EGG-SSDC-5288

HUMAN FACTORS ENGINEERING EVALUATION OF  
THE ADVANCED TEST REACTOR CONTROL ROOM

M. P. Boone  
W. W. Banks

Figure 1. PPS control panel and process instrumentation.

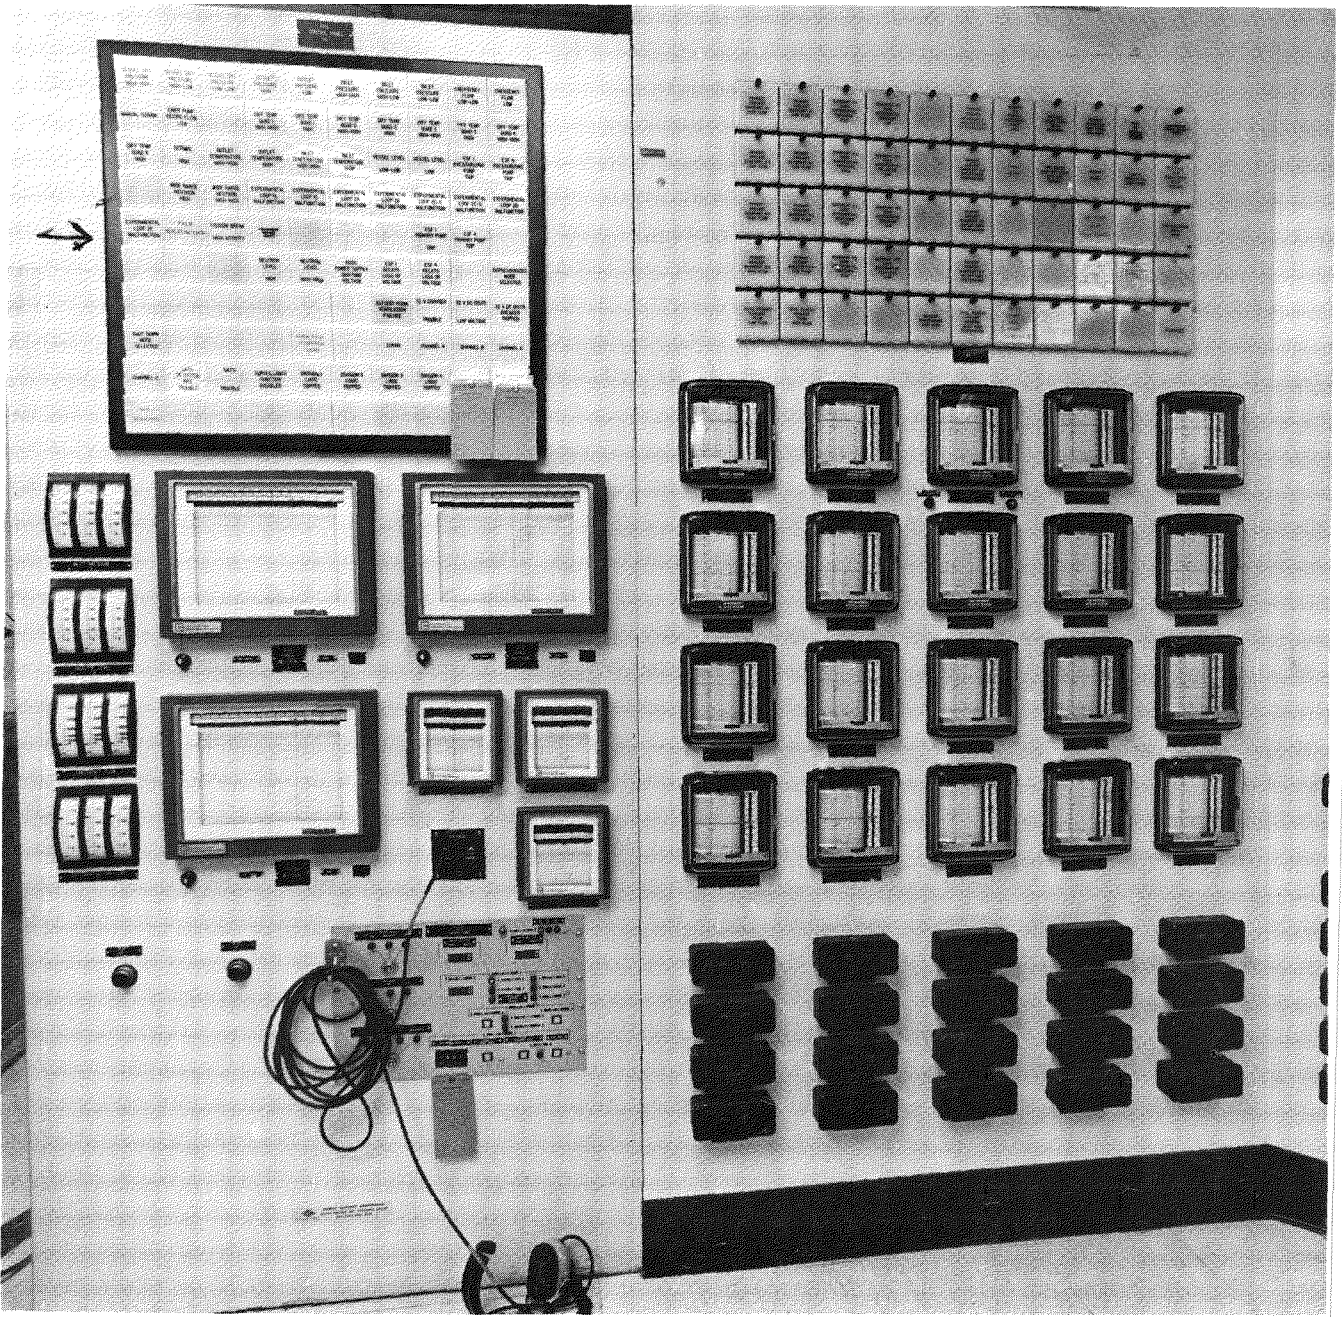
From a human-factors viewpoint, these nonfunctional elements constitute visual noise, take-up space, and provide no direct positive assistance to operators. An examination of Figure 1, for example, shows Panel No. 7 to have 14 blank or nonfunctional elements.

Figure 2. Data System Alarm. (Note the varying contrast of different windows.)

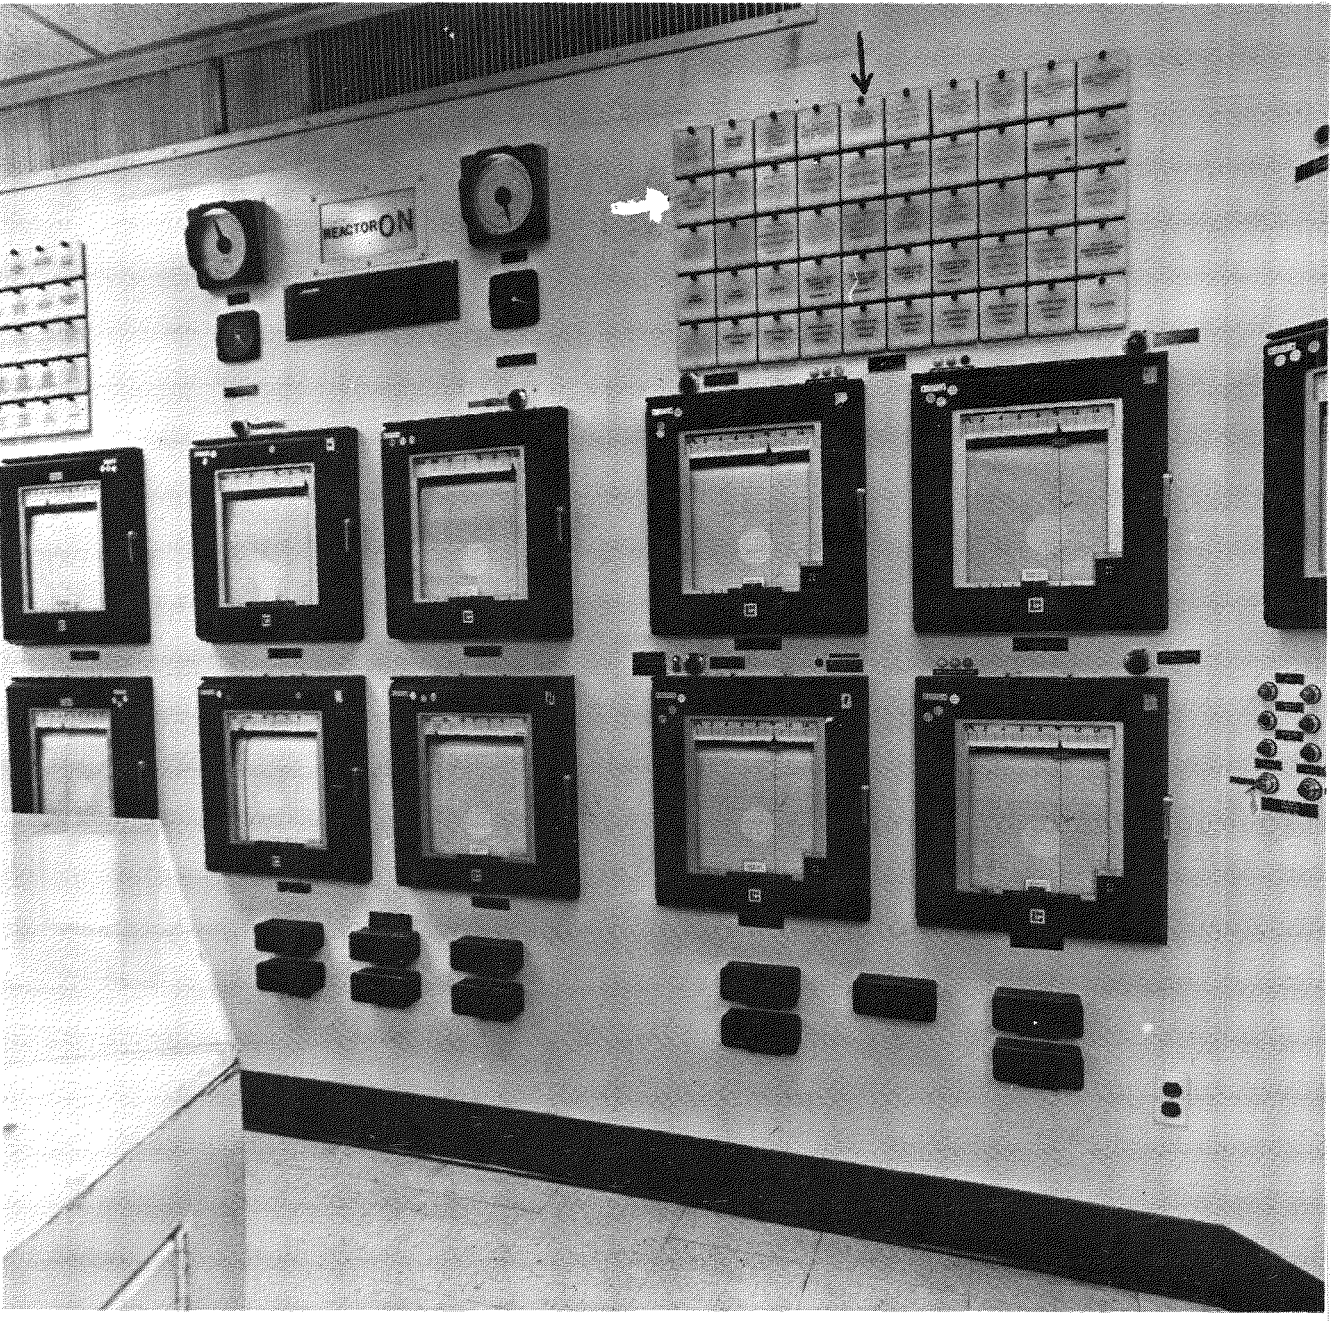
Valid Information. Figure 2 depicts annunciator No. 10 in a cluster. It was noted during our evaluation that the data system alarm element (shown by the arrow) can be "cleared" with the acknowledge button, but in reality the problem which caused the alarm is not cleared. We recommend the visual (not auditory) alarm stay on the board until the condition has actually cleared.

All letters, numerals, and symbols on annunciator elements should have the same contrast ratio when visually examined. Four different levels of contrast (figure to background) were noted on the present annunciator elements. Examples of this may be seen by examining Panel No. 10 (see Figure 2) and the following elements:

It is recommended that only one character size and contrast ratio be used on the annunciator panel. The luminance-contrast ratio should be at least 85%.<sup>a</sup>

Figure 3. Position of annunciator acknowledge switch

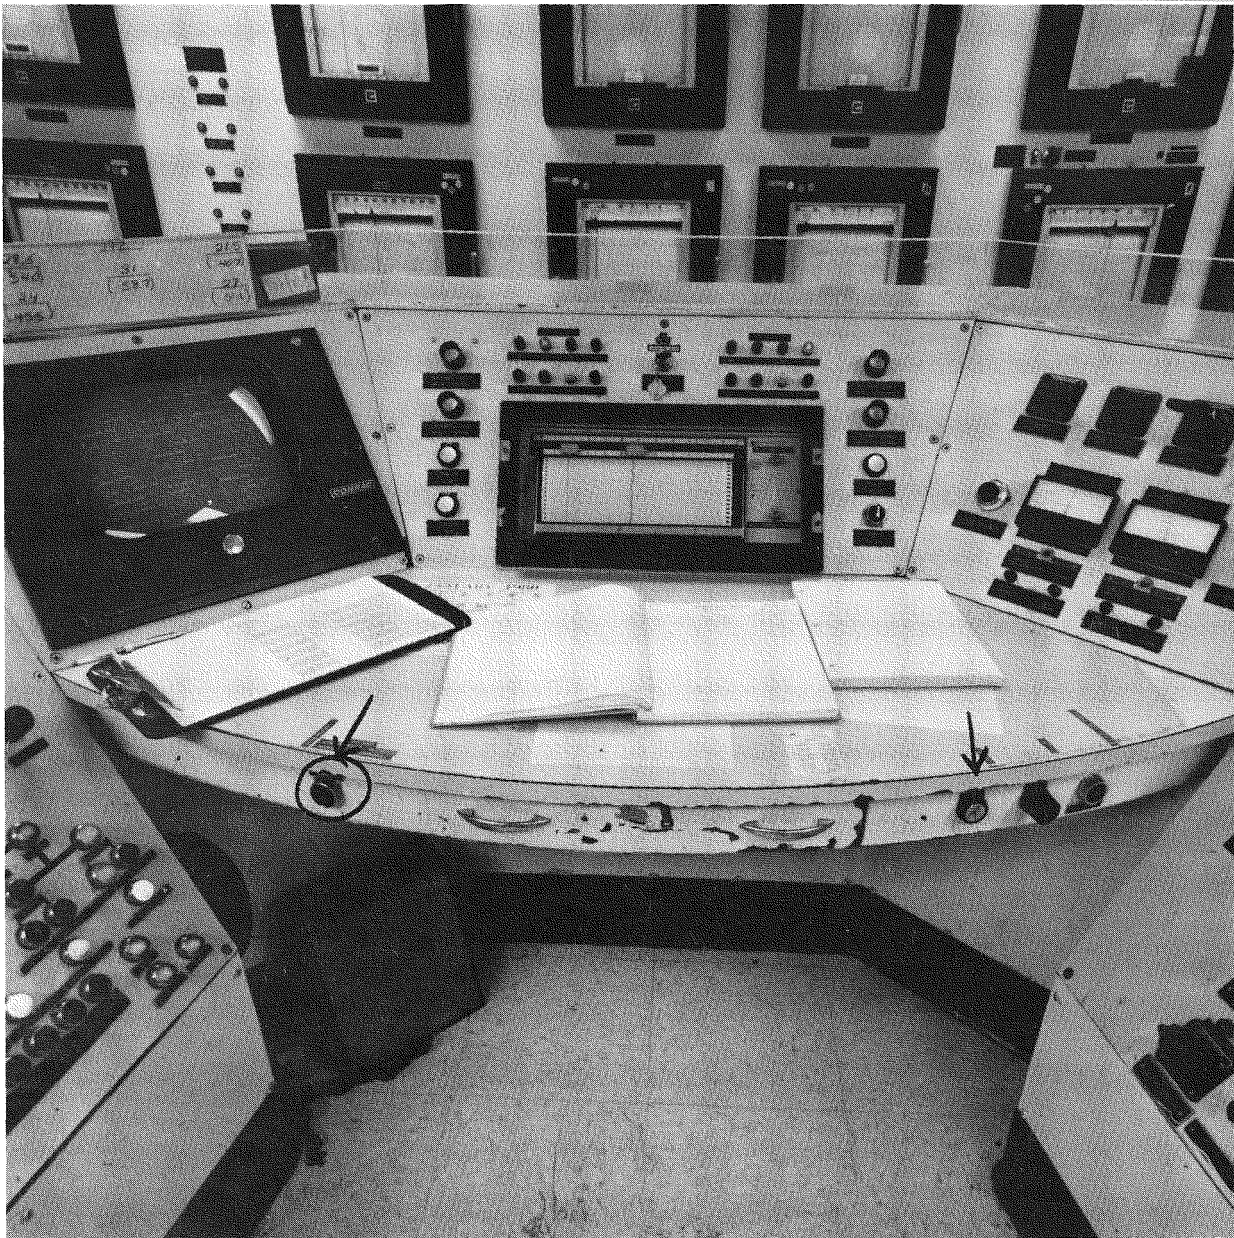
Questionable Alarm Disabling Procedure. During the course of our evaluation, we observed a paper clip being inserted into the annunciator acknowledge button. The reactor was down and the operators were going through their normal PM inspection lists. We inquired about the paper-clip procedure and was told the clip was used to prevent the audible alarm from sounding. During shutdown, many set points are readjusted. The readjustment causes an audible and visual alarm in the control room. These alarms are not always

meaningful and are considered by some operators to be distracting. If these alarms are going to continue to be locked out, a more formalized engineering procedure needs to be established (see Figure 3).

Figure 4. ATR evacuation and evacuation direction switches.

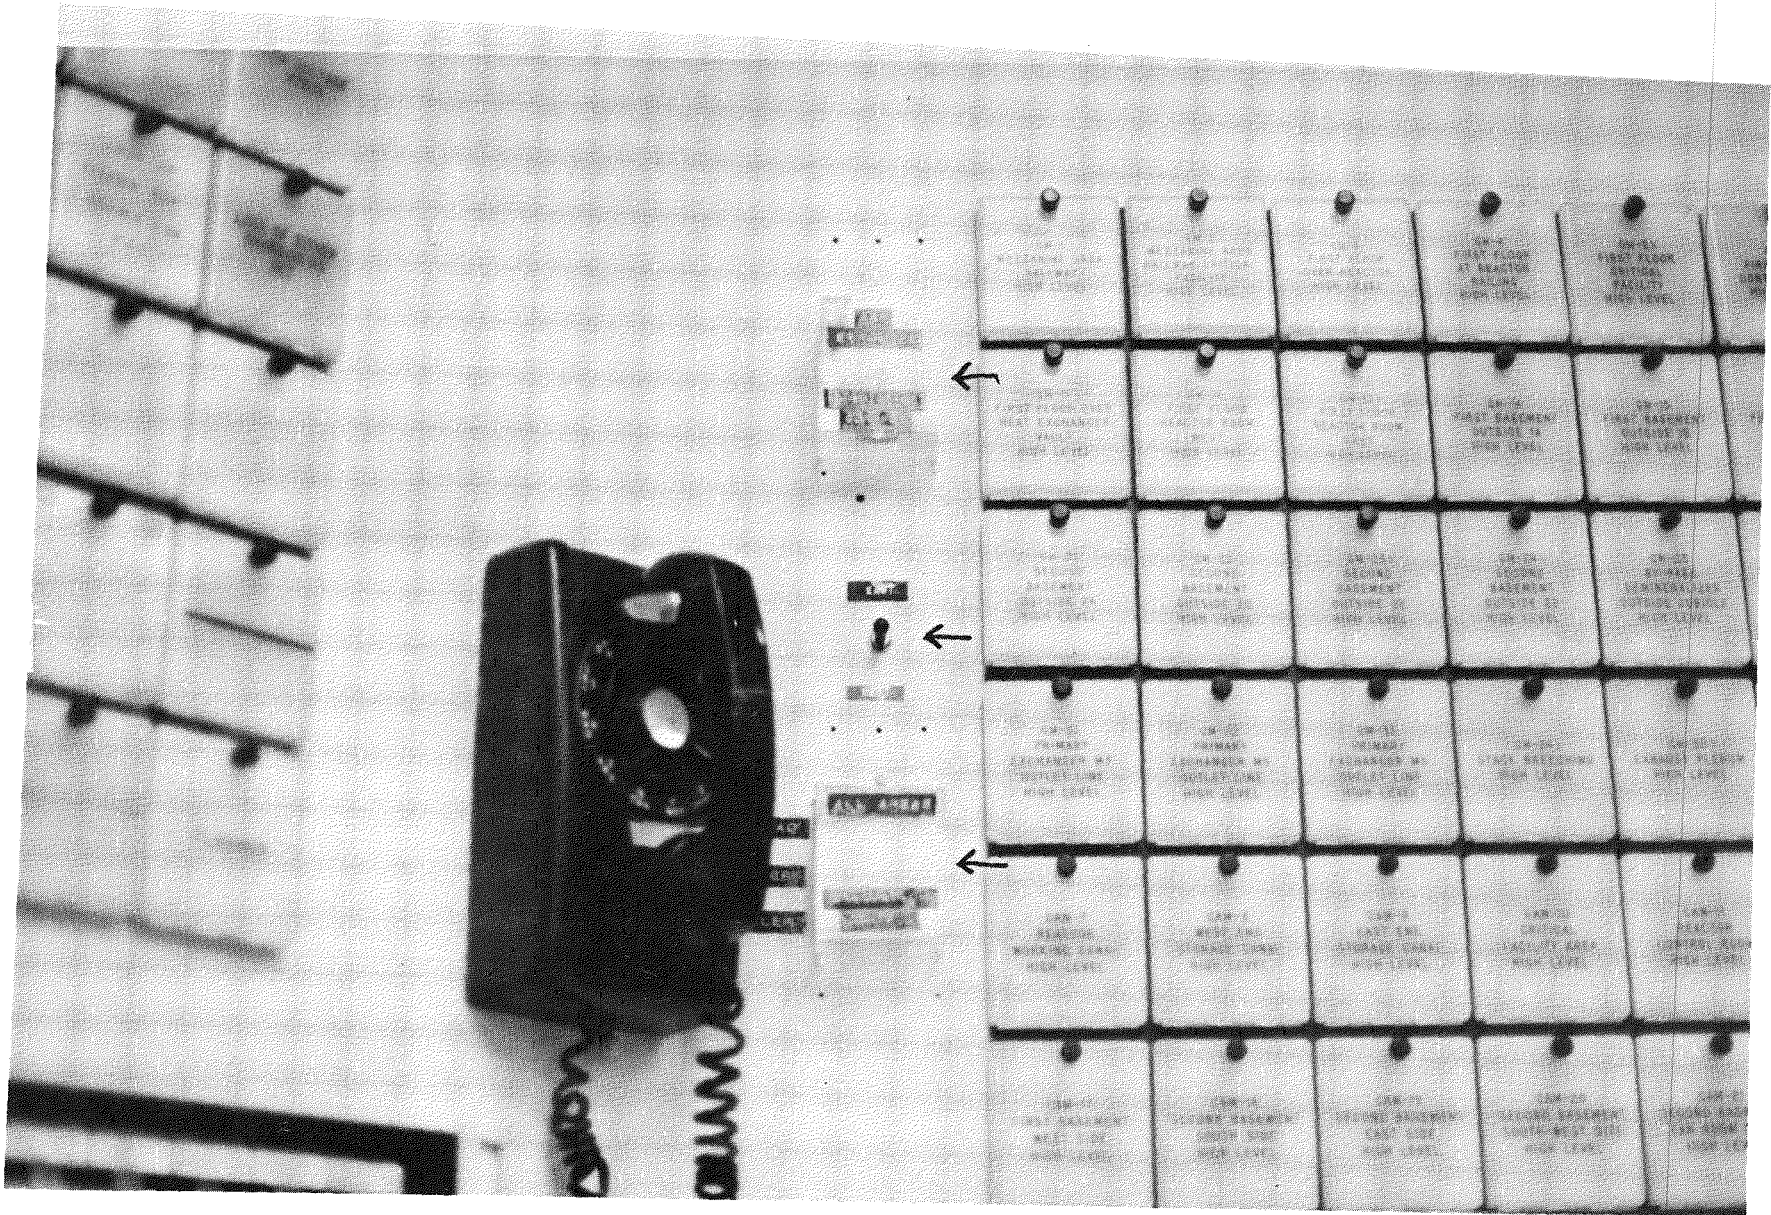
Physical and Visual Accessibility. The ATR evacuation and evacuation directions switches are out of the reach envelope of at least one operator. The switches are respectively 7-1/2 ft and 7 ft from the floor. Because these controls function to provide emergency information to site workers, they should be in the physical reach envelope of all qualified operators. Figure 4 shows the relative position of these switches. It is recommended that these instruments be moved so that they are within the standing reach envelope of the shortest operator.

Figure 5. Channel 4 and 5 overall range viewers.

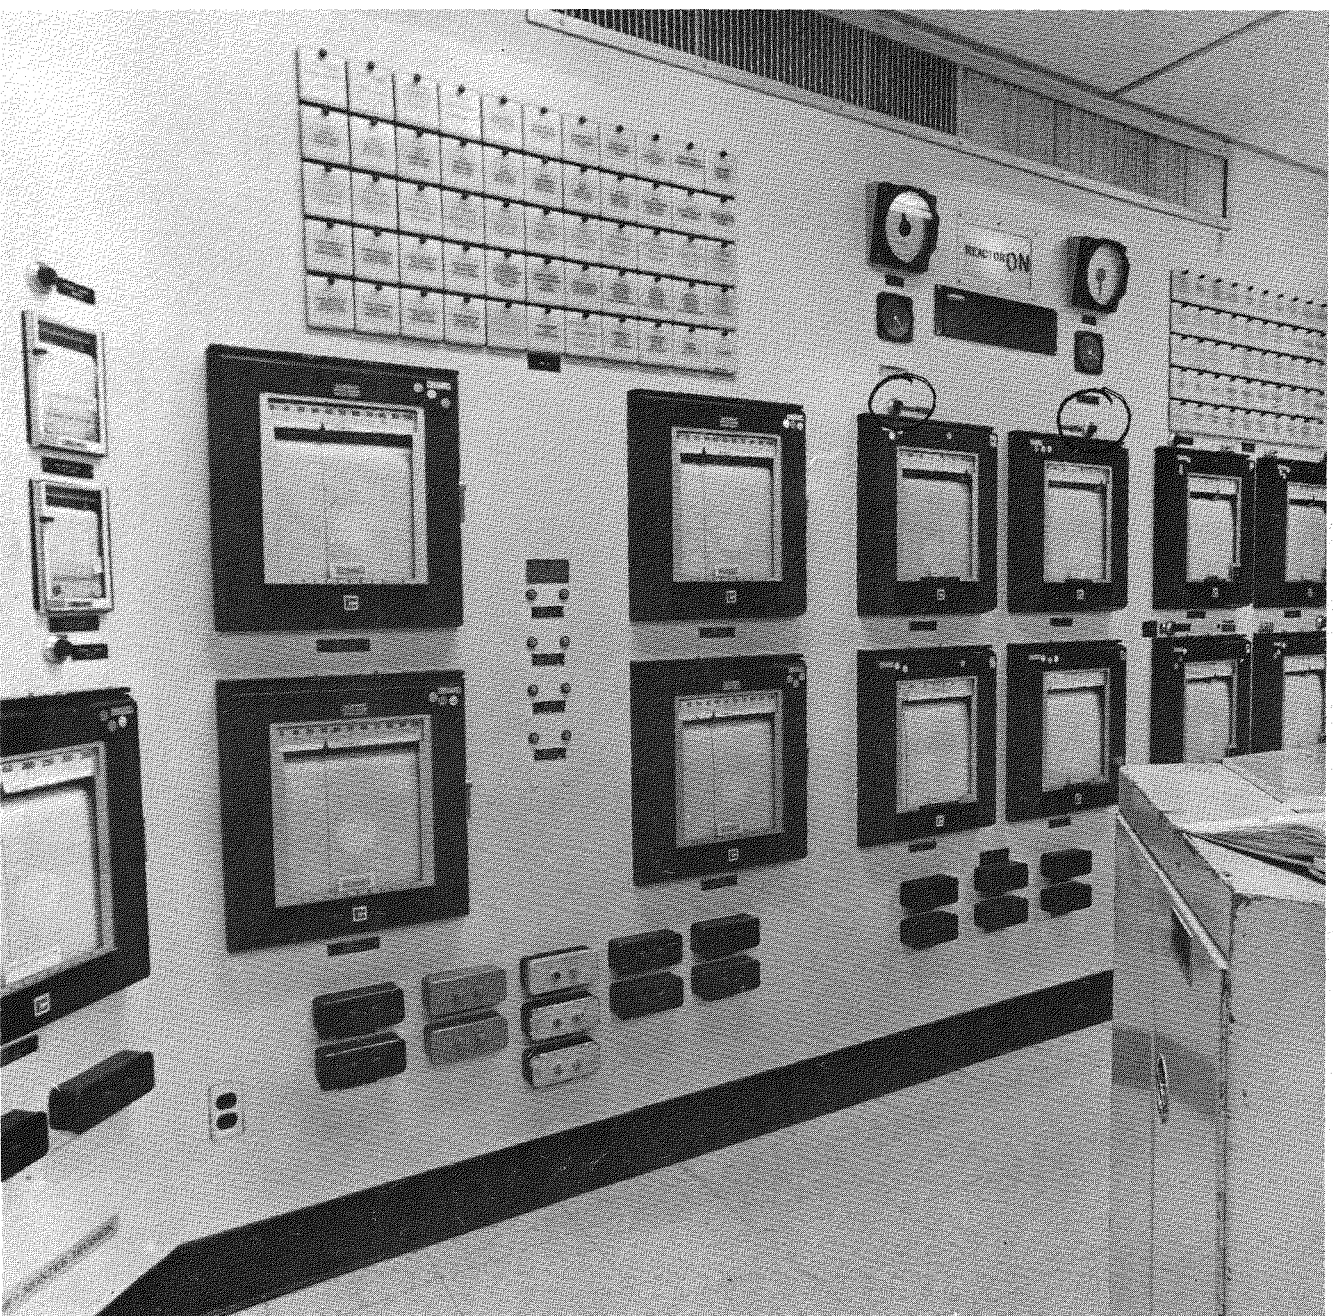
Three of the seven operators we informally interviewed stated that they have difficulty in reading the top scale of the log-N overall range adjust vernier (Channel 4 and 5) control (see Figure 5; circles). An incorrect adjustment here would result in an improper set point and would, therefore,

give misleading readings of  $N_L$  and  $N_F$ . This would also incorrectly set the threshold-activation point for the annunciator element and result in a false alarm or missed alarm signal.

Therefore, it is recommended that the log-N overall range adjust be repositioned by at least 8 in. to a lower point on the control panel.
